Detroit
Edison

Reference: Enrico Fermi Atomic Power Plant, Unit 2
NRC Docket No. 50-341

Subject: RCIC Suction Switchover, H.II.K.3.22

SIMPLIFIED LOGIC DIAGRAM OF
RCIC AUTOMATIC SUCTION SWITCHOVER
H.I.K. 3.22

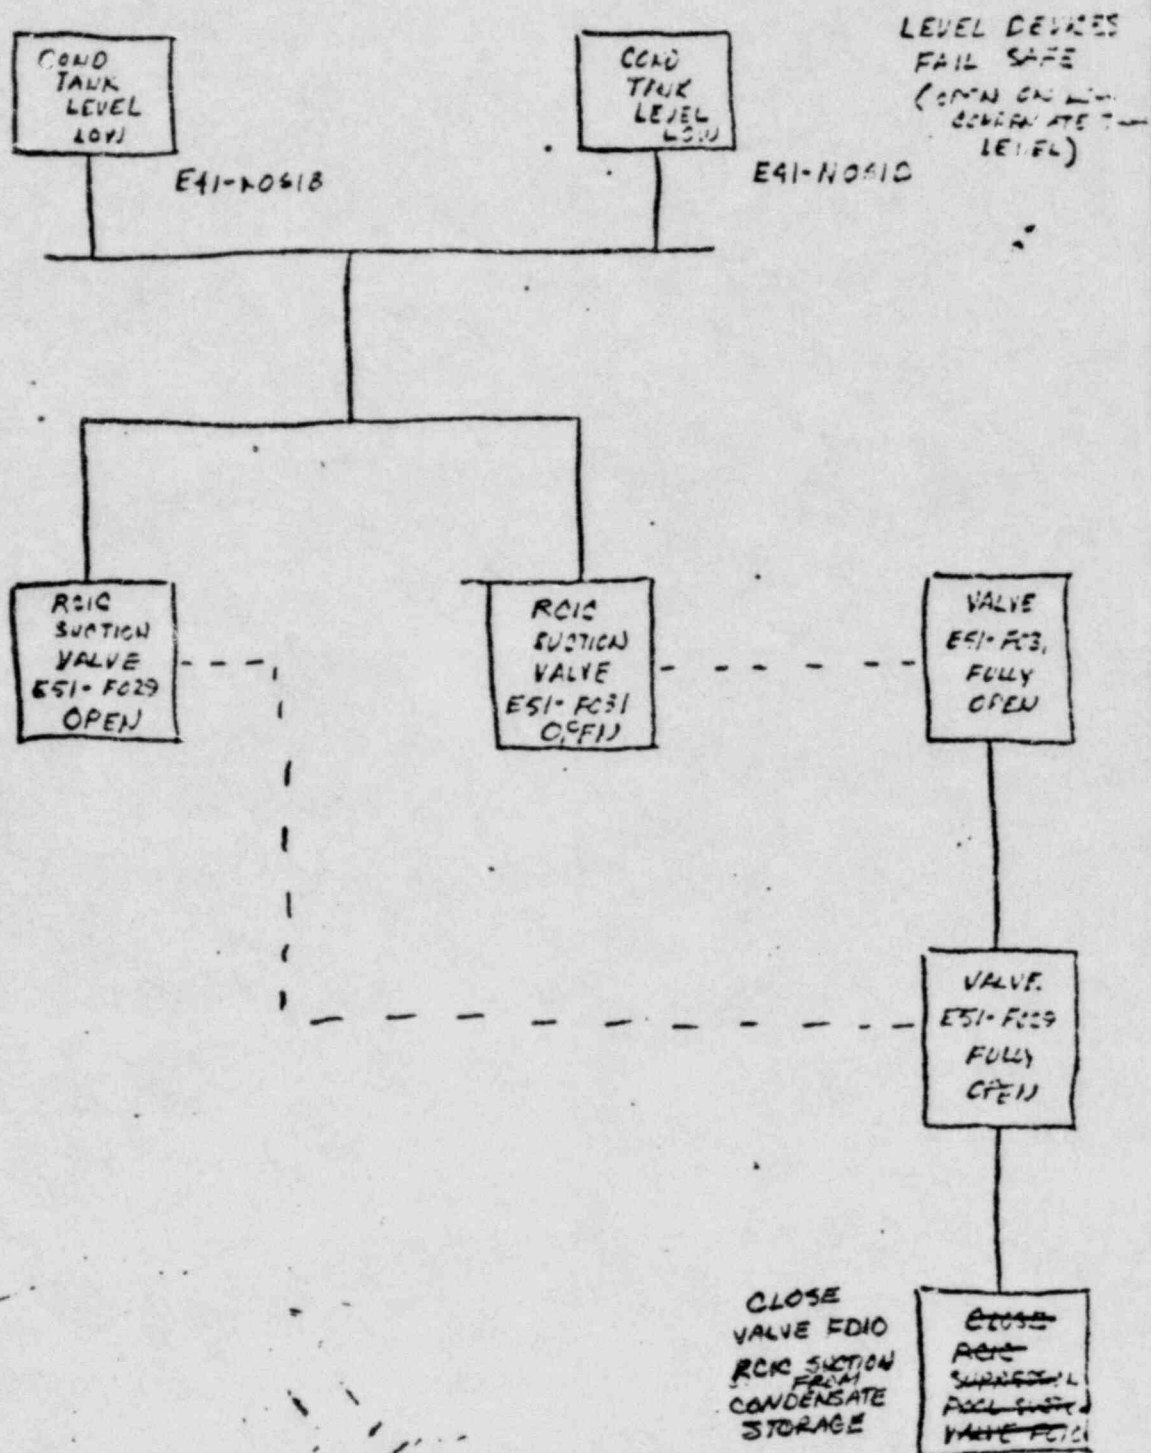
Per a discussion with G. Mauch, Detroit Edison has revised the text and logic diagram to correct the error which was made in referring to a valve E51-F010 as the suppression pool suction valve. The FSAR will be corrected as indicated in the attached sheets.

A single failure proof automatic transfer of the RCIC suction lineup from the condensate storage tank to the suppression pool will be ~~be~~ installed. This change will utilize the existing redundant analog transmitter/trip unit, ^{condensate storage} tank level measurement which has been provided for the HPCI system. A de-energize-to-operate relay logic derived from the level measurement channels will automatically open RCIC valves F029 and F031 (refer to FSAR Figure 7.4-1) on low condensate storage tank level. The logic utilizes the full open position limit switches on F029 and F031 to initiate closure of F010 which is the valve in the pump suction connection to the ~~suppression pool~~. ^{CONDENSATE STORAGE TANK.} Panel status information is provided for the operator in the form of valve position indication and an alarm if the operator closes either suppression pool suction valve while the condensate storage tank level is low.
